Item: Jewell Addition Apartments – 1110, 1116, 1120 American Avenue

Presented By: Brad Eatherly, Planner I, Planning and Community Development

Action Requested: Approve the submitted design with conditions.

SITE PLAN

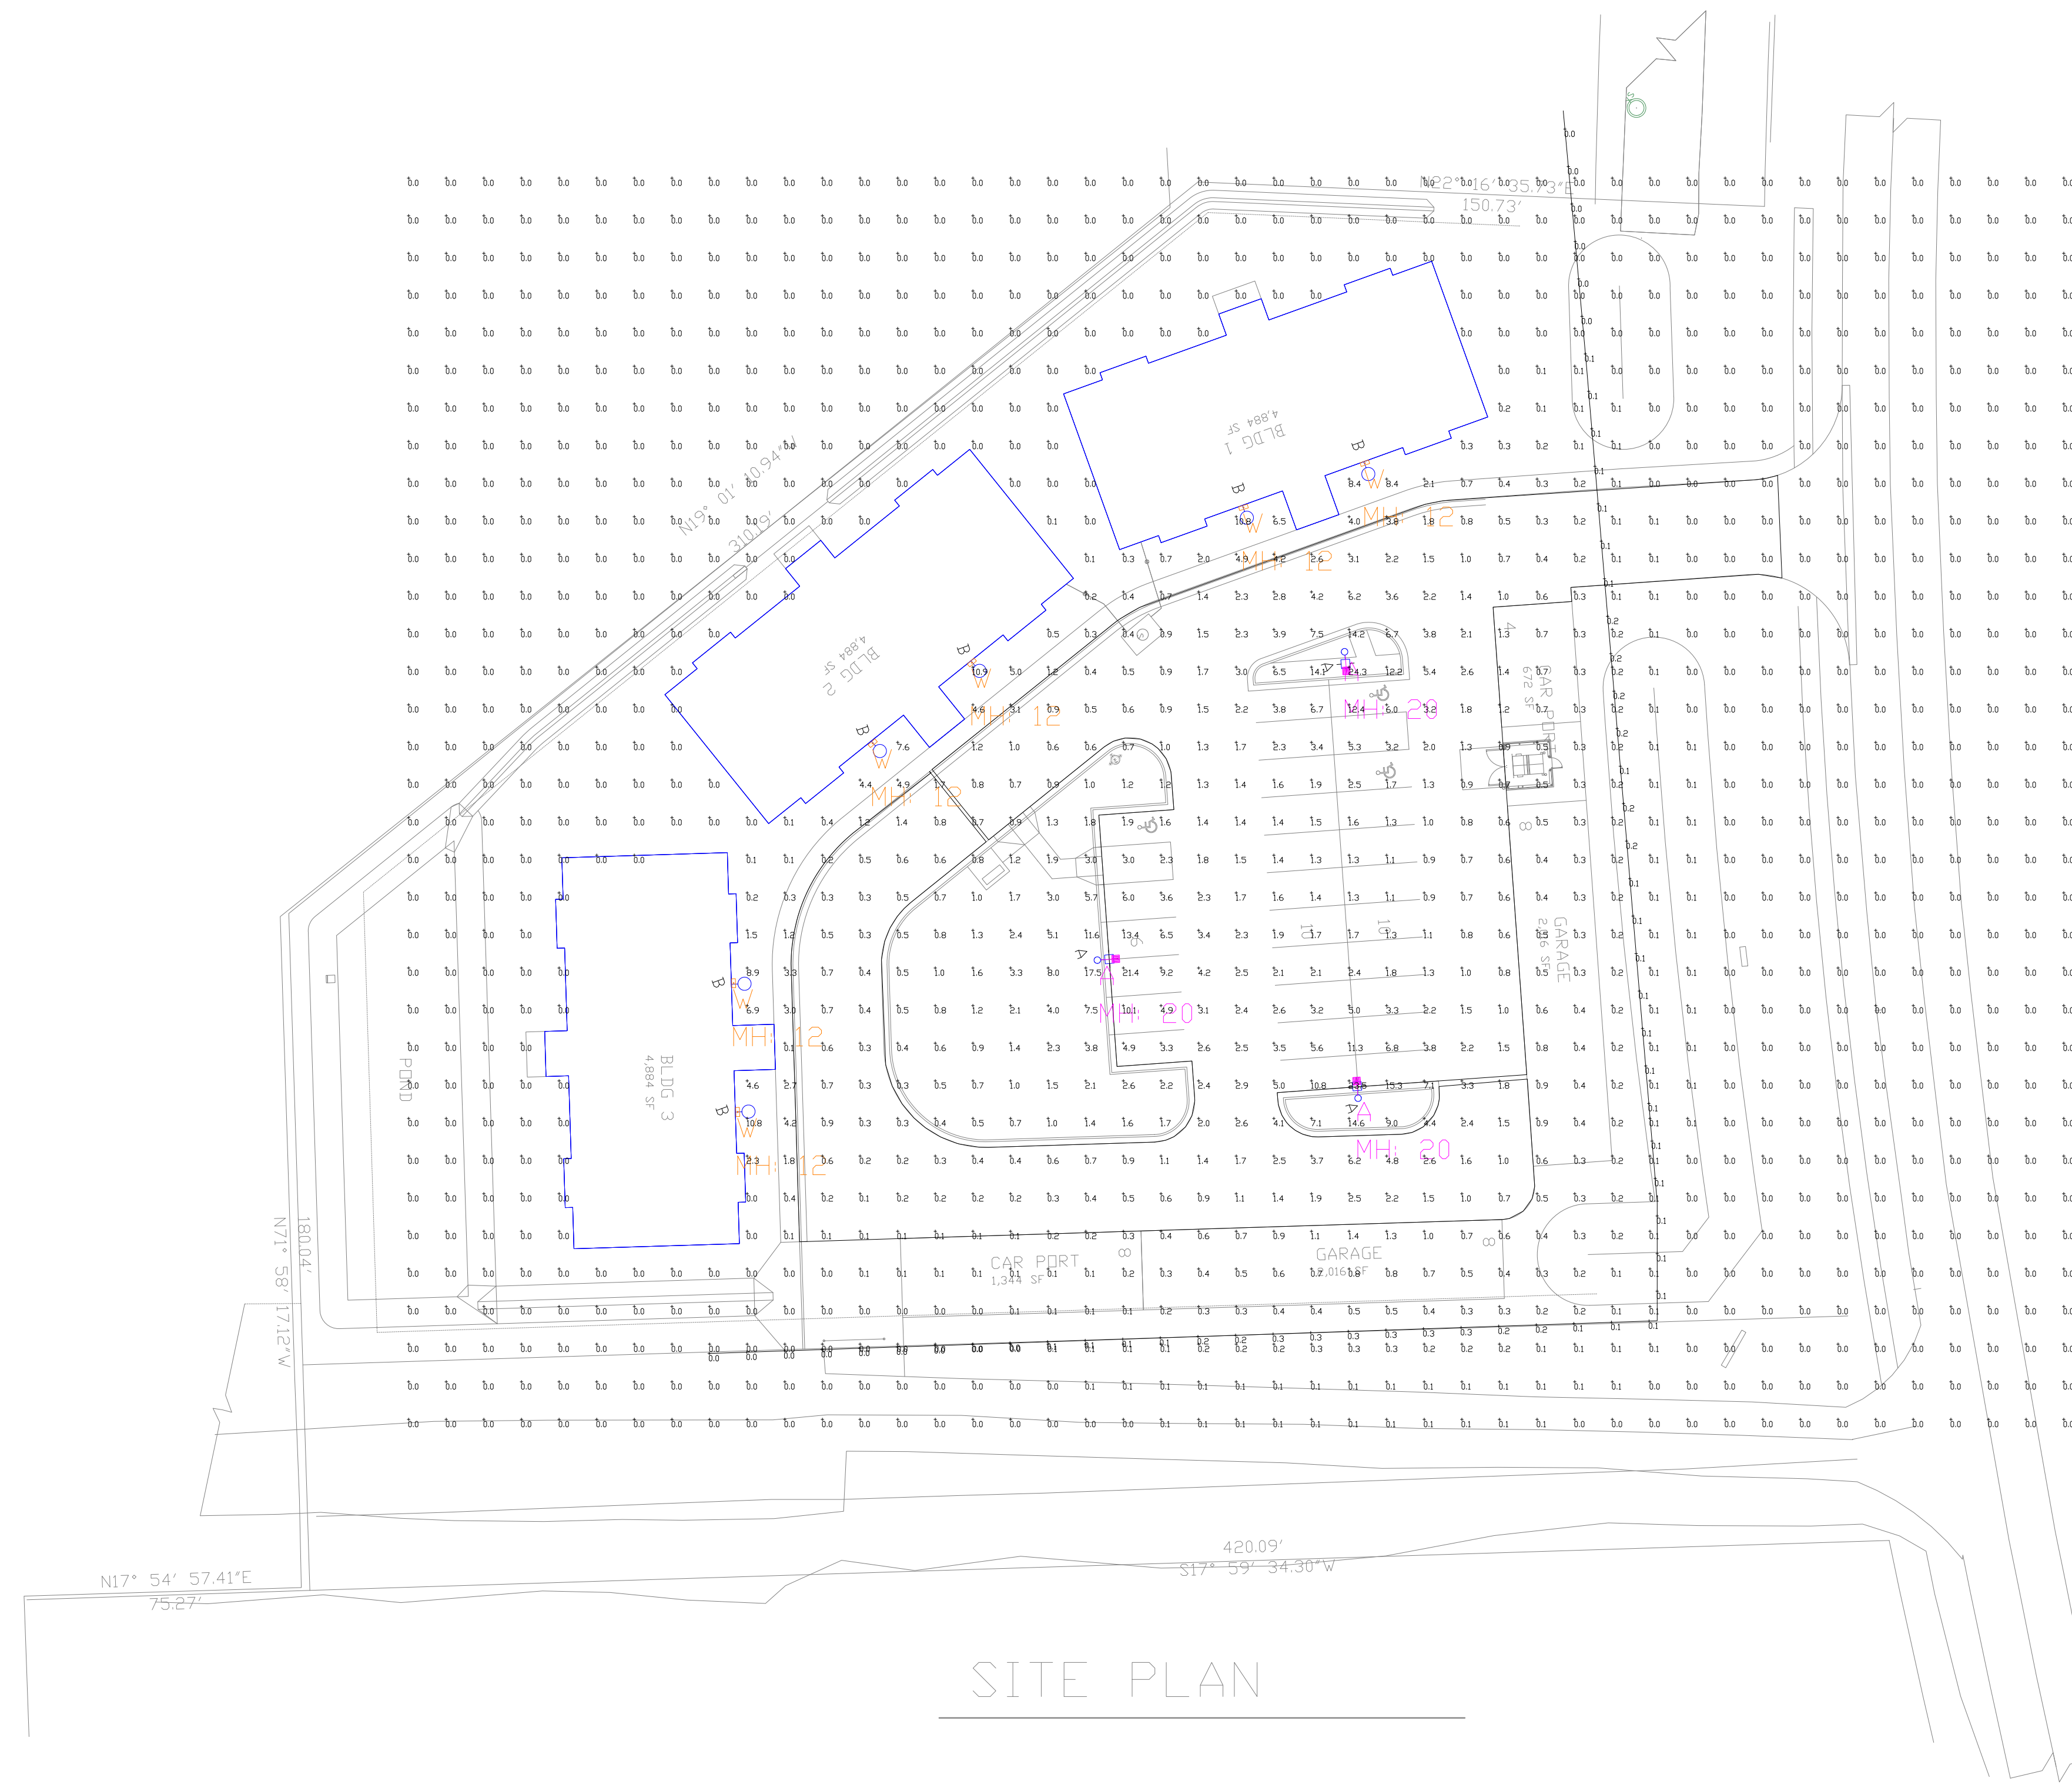
The applicant has provided an outdoor lighting plan which is in compliance with the requirements of Chapter 40 - Outdoor Lighting of the OCCGF. The proposed lighting plan provides lighting mounted on the building and pole mounted lighting. The proposed lighting plan and specifications show full downcast fixtures to prevent light pollution and meets all averages as set forth in the OCCGF.
